Technical Service Bulletin

Source:	Prestolite Electric Ltd - Greenford, London, UK
Date:	October 16, 2017
Bulletin No:	TSB4032_66021507
Models:	AC5RS & AC5RSM
Subject:	Alternator supersession

AC5RS / AC5RSM Supersession

66021507 Wiring

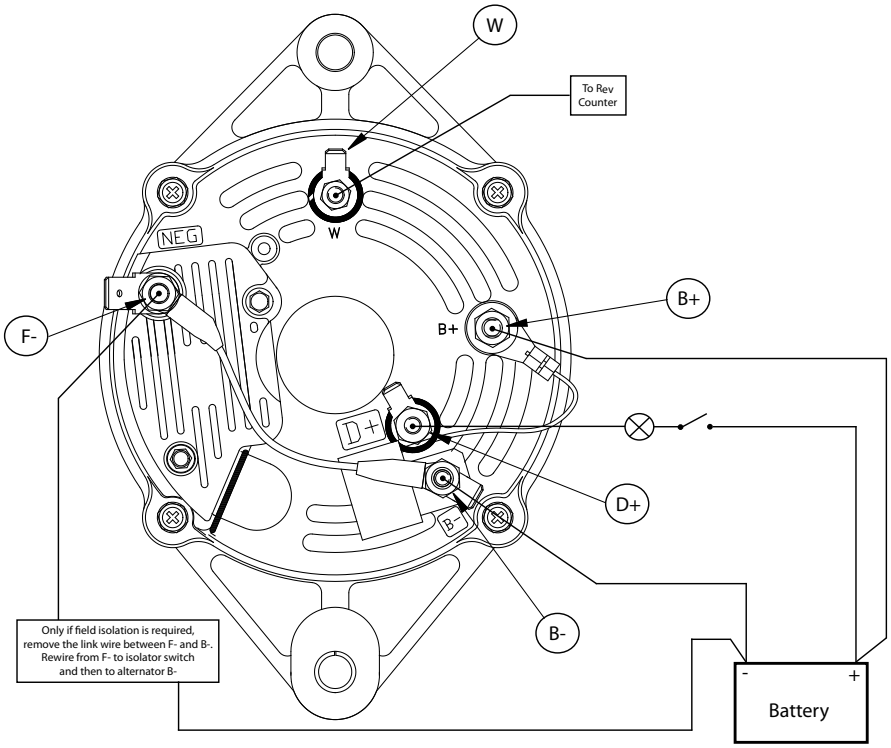
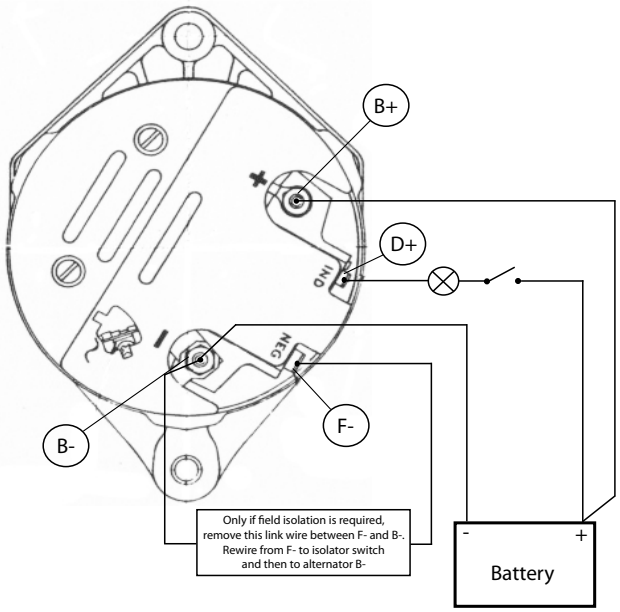
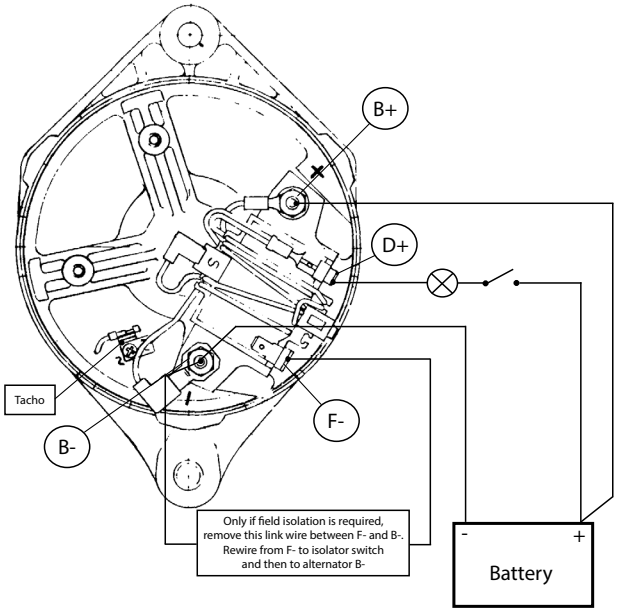
The standard version (AC5RS) has been superseded by part no. 66021507, which is an AS128eHD type alternator.
All the mechanical fitting are identical. The new alternator also has all the same electrical connection, but in slightly different positions. See page 2 for wiring diagrams.

The marine version (AC5RSM) could also be replaced by the 66021507. The mechanical interface is the same (i.e. mountings, and shaft), however the new alternator does not have a marine finish and the wiring (termination) on the boat would need to be adapted to suit new style alternator.
